COLLIN COUNTY, TEXAS

ADDENDUM No. Two (2)

IFB No. 2019-109

CONSTRUCTION, ROAD: OUTER LOOP ACCESS ROAD, DALLAS PARKWAY TO EAST OF SH 289

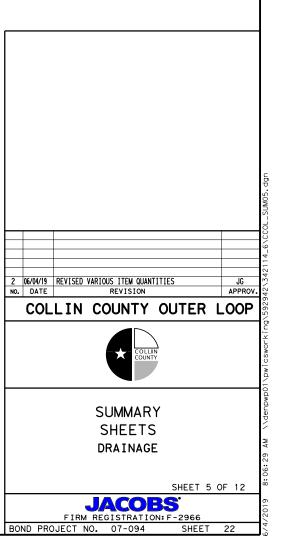
Can you please provide a beam layout for the BNSF Overpass Bridge?

Plan sheets 287A and 289A added to the Contract plans. Updated plan sheet 002 index of sheets. (See Attached Sheets)

SW3P PLAN ACCESS ROAD

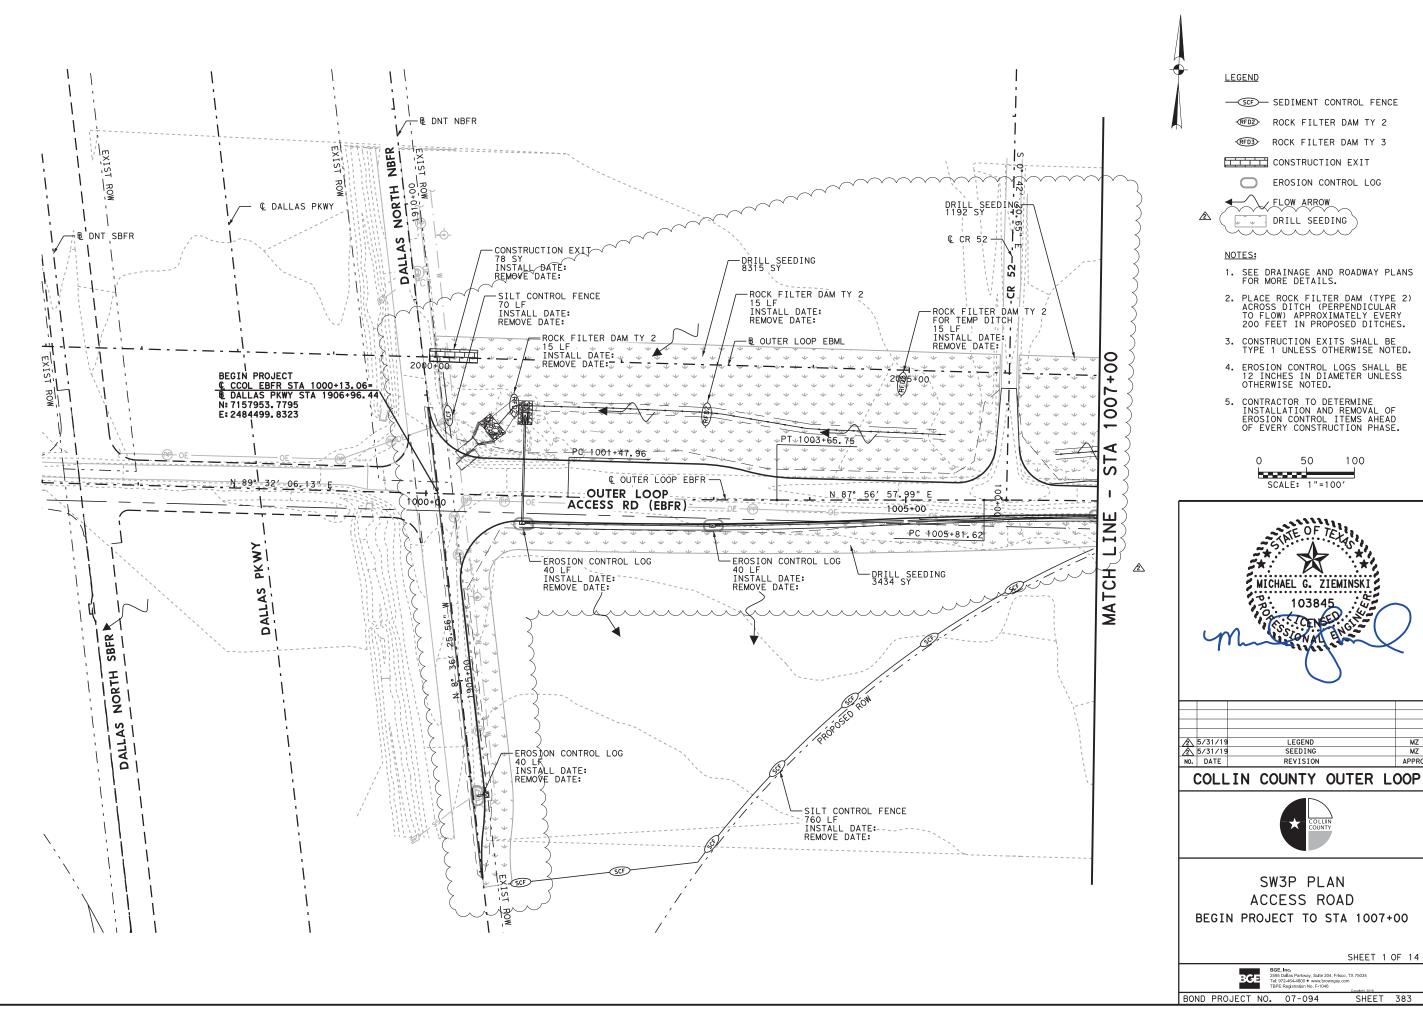
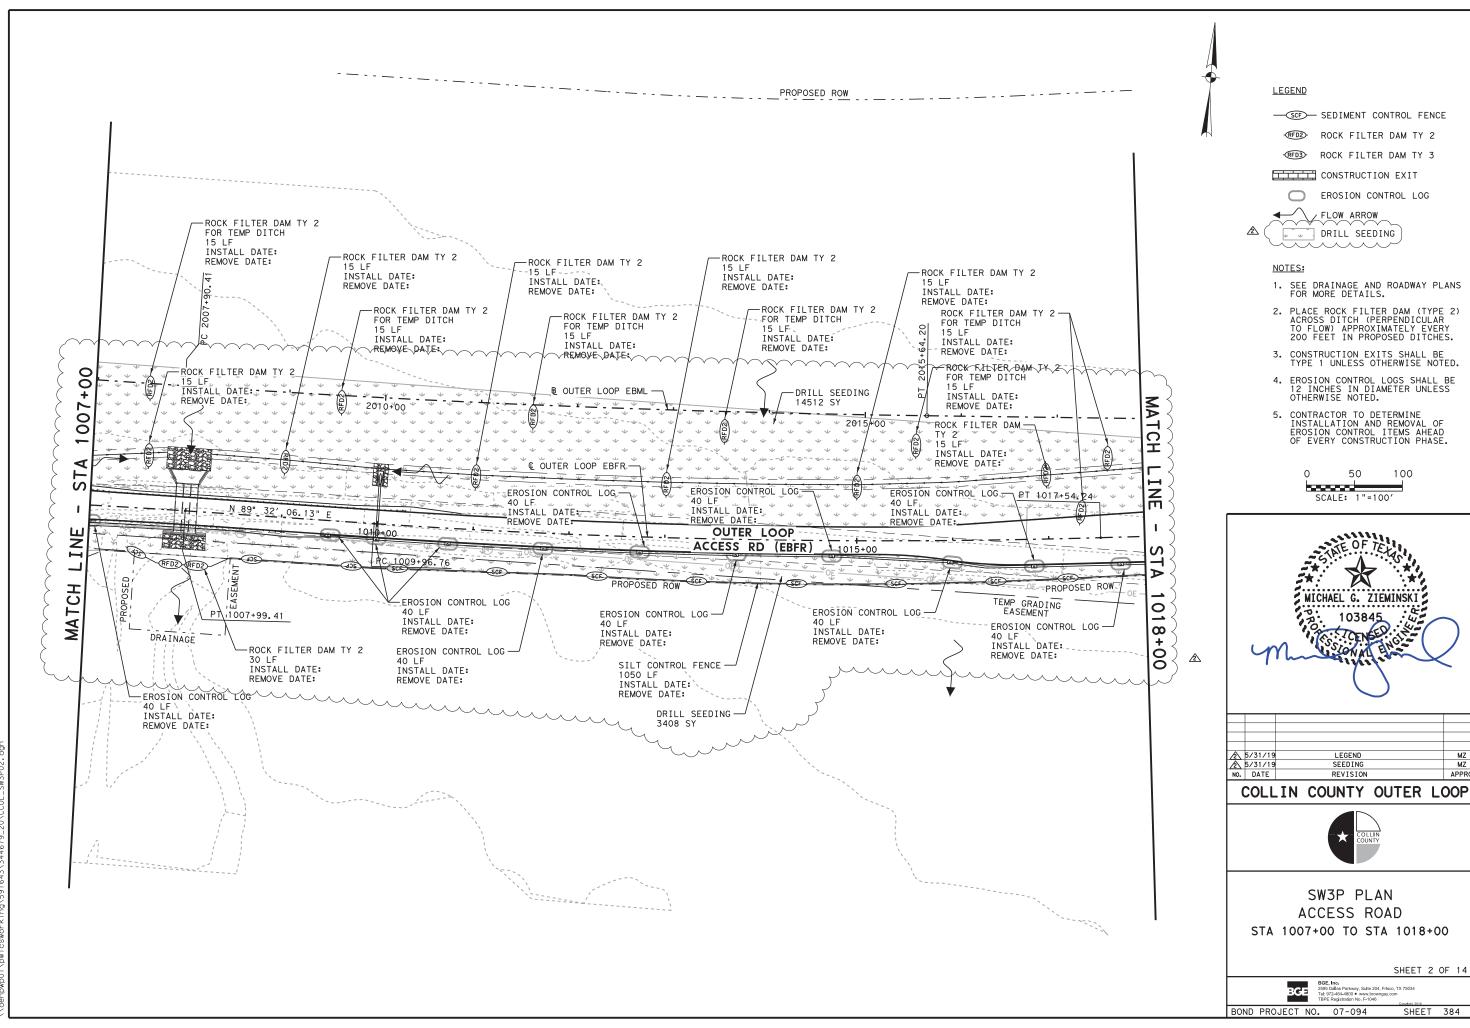
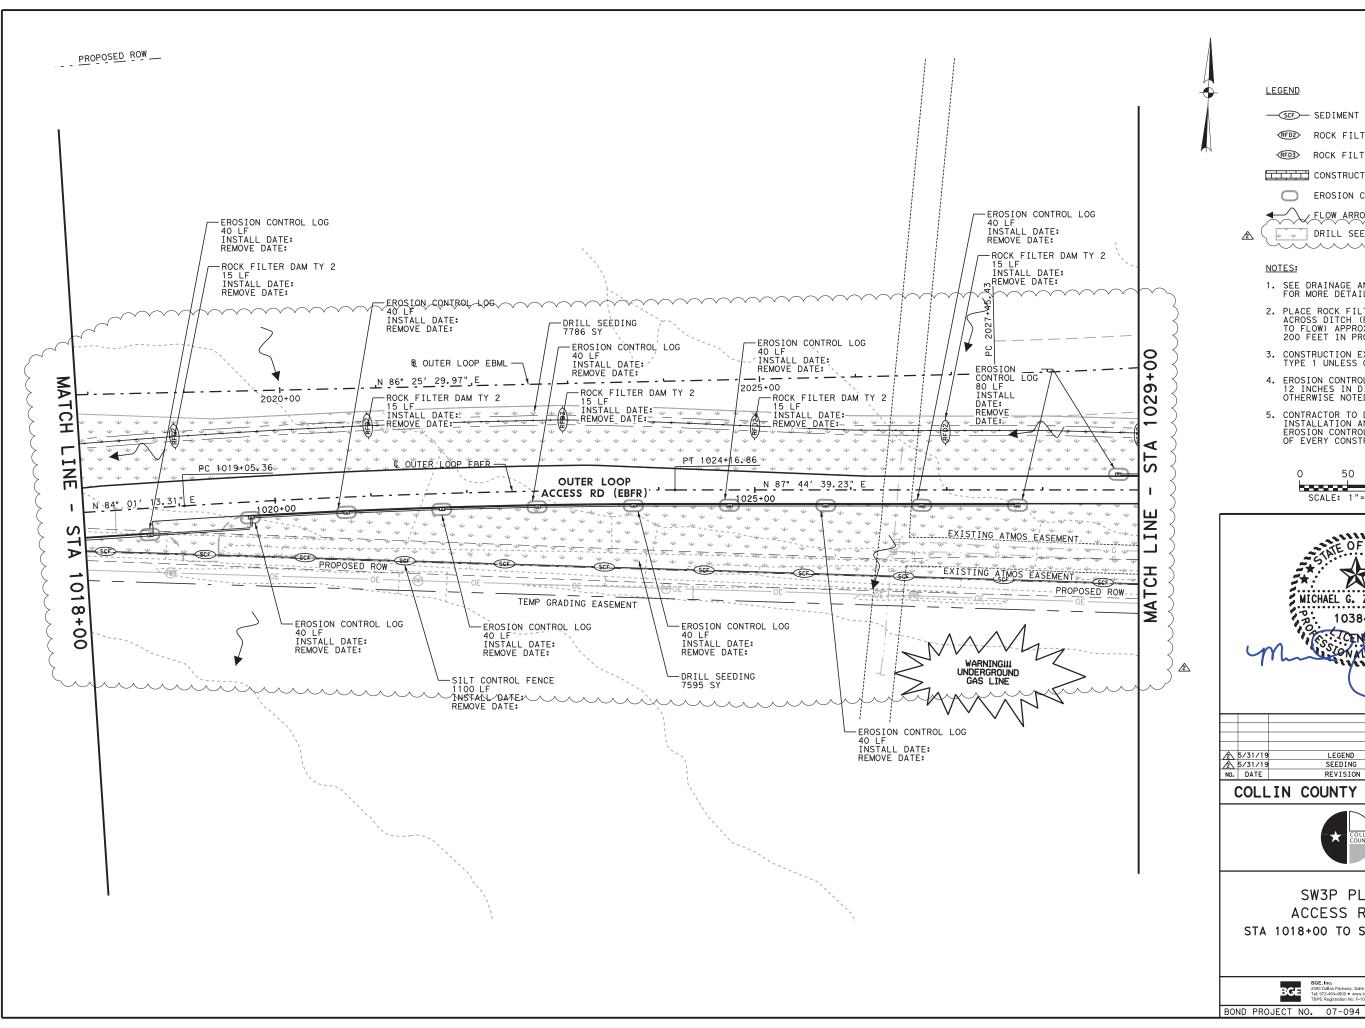
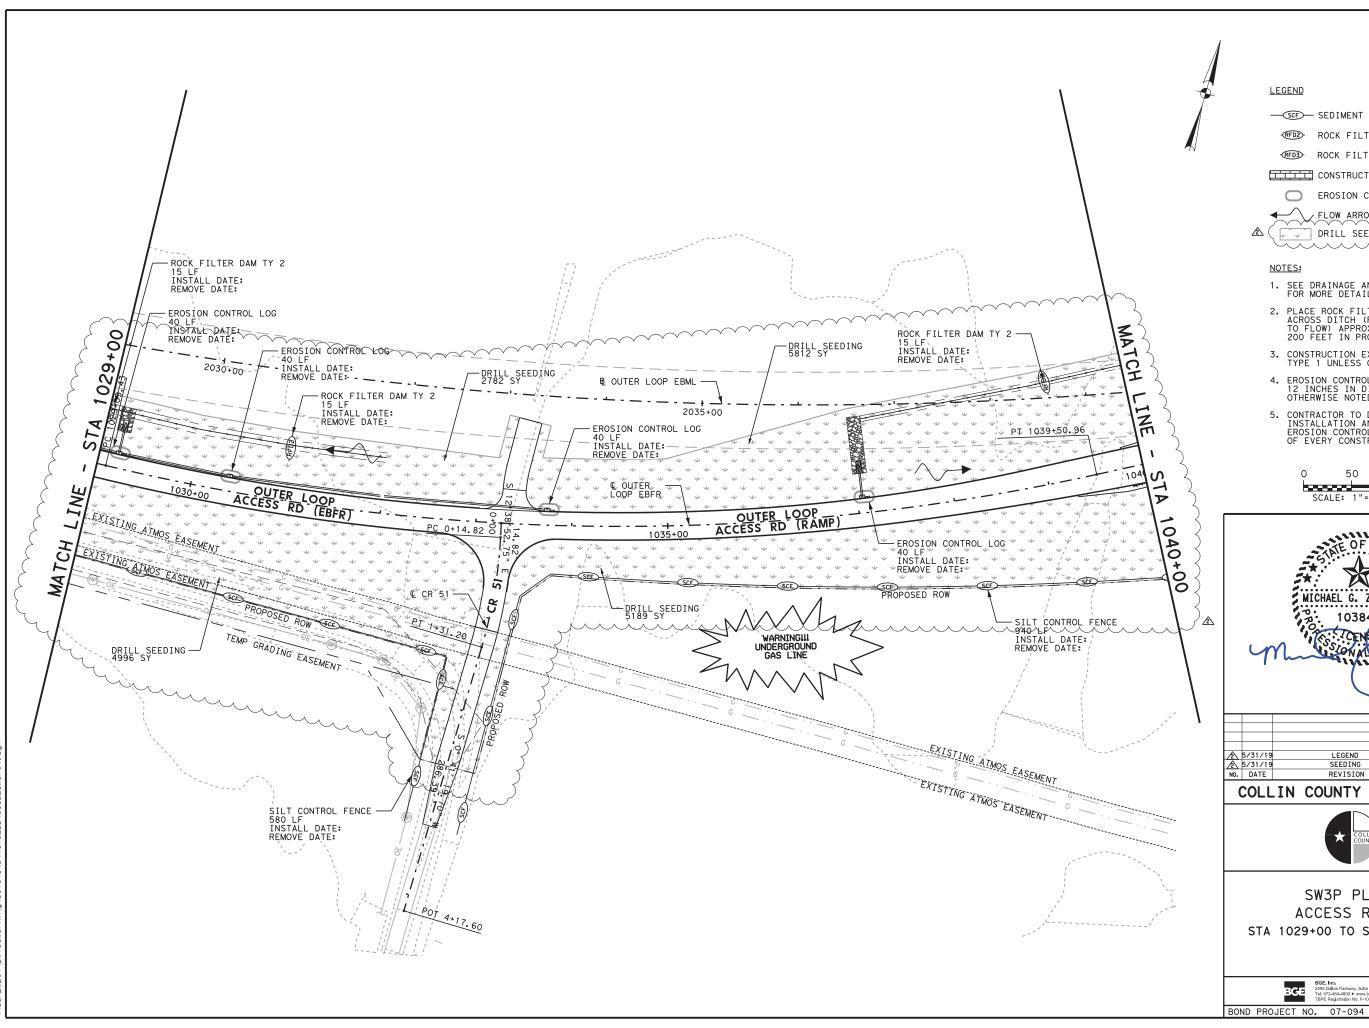
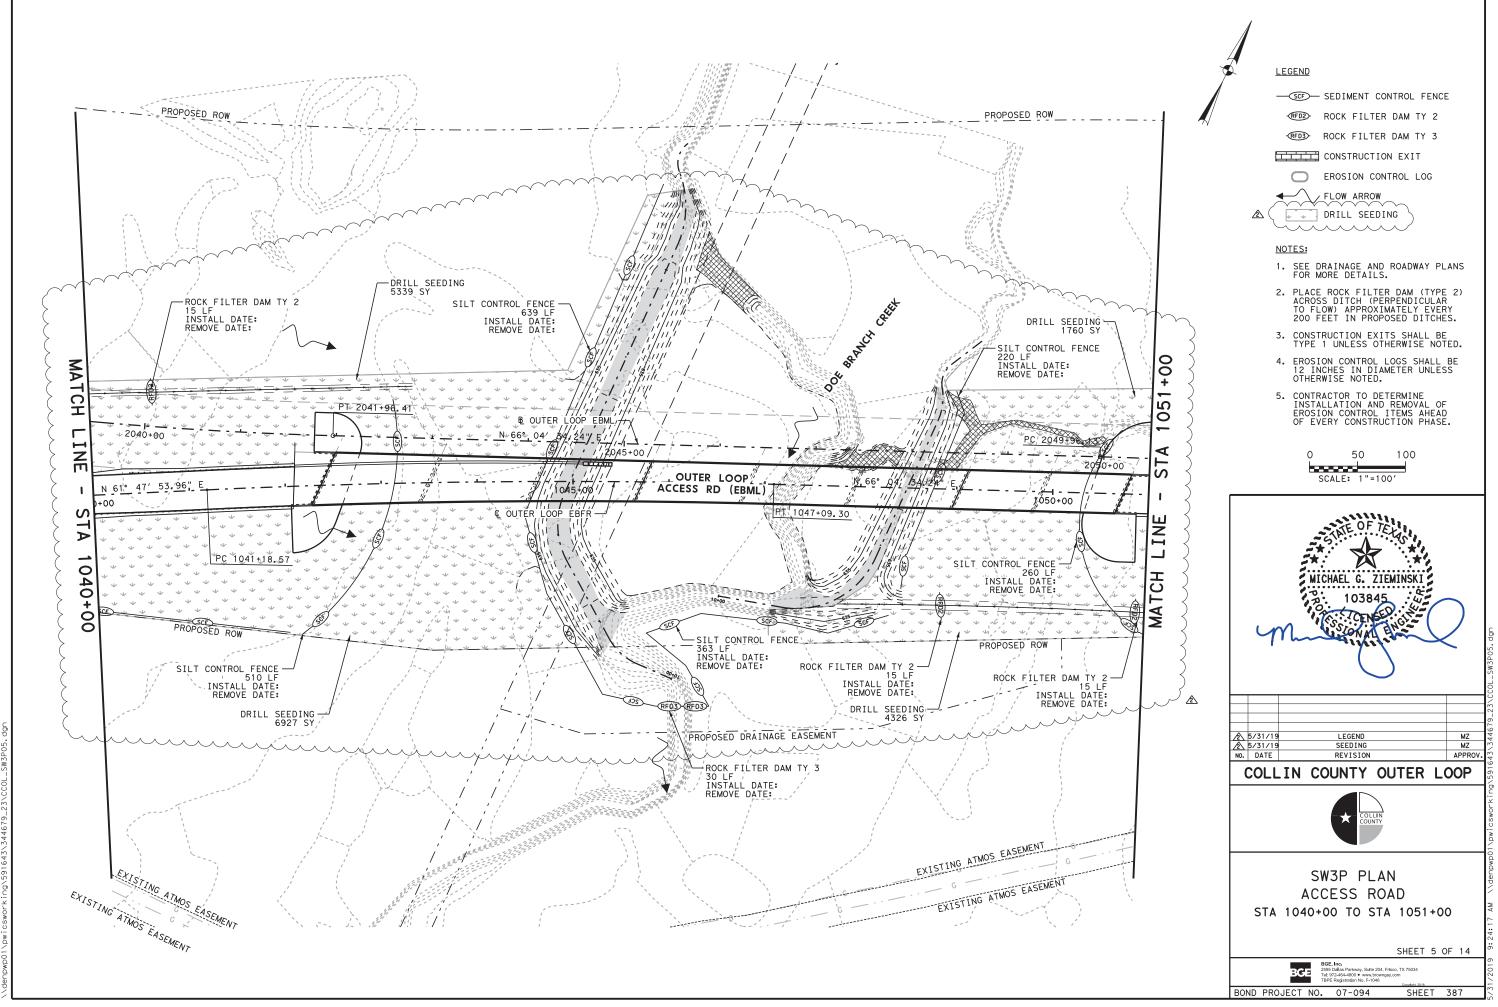
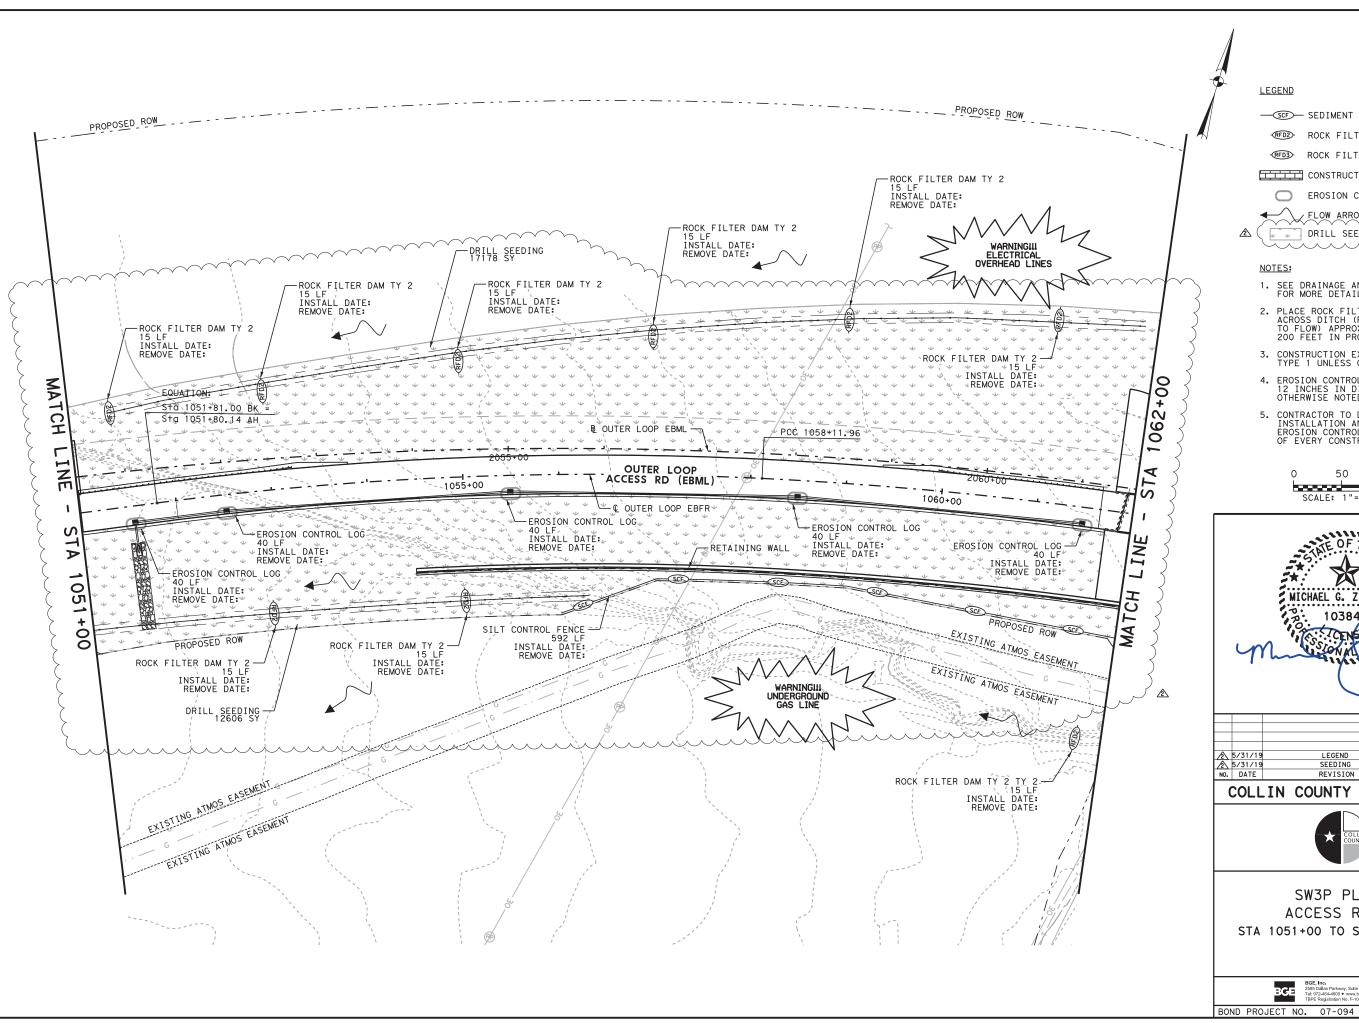
Please provide plan sheet showing the limits for item 164 6066 DRILL SEEDING (PERM) (WARM OR COOL) 496,880 SY.

Seeding now shown on SW3P layout sheets, Plans sheets 383-396. Quantities updated in plan sheets EQ1 and 28 and bid book Pg 39-40. (See Attached Sheets)

General Notes

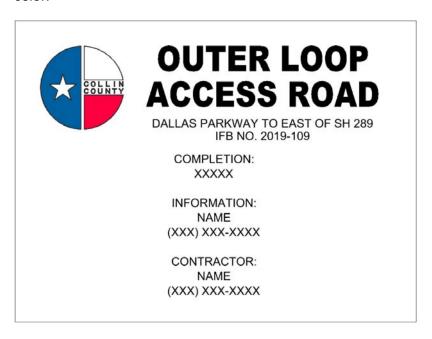
Page 79 of the proposal Says that no work shall be done on Nights, Sundays or regular Holidays unless permission is given by owner, but then page 232 "Sheet D" says that this project will be a Five-day work week and nights work is allowed. Then also on page 239 it says "Do not commence work on the road before sunrise. Please clarify what is the correct requirements for this project? Will there be work allowed at night? will work be allowed on the weekends? Is this project based on a 5-day work week?

Work will be allowed on Saturdays, Sundays, and on nights with approval of the OWNER. Updated bid book Pg 239 Item 239 to remove "Do not commence work on the road before sunrise". (See Attached Sheets)
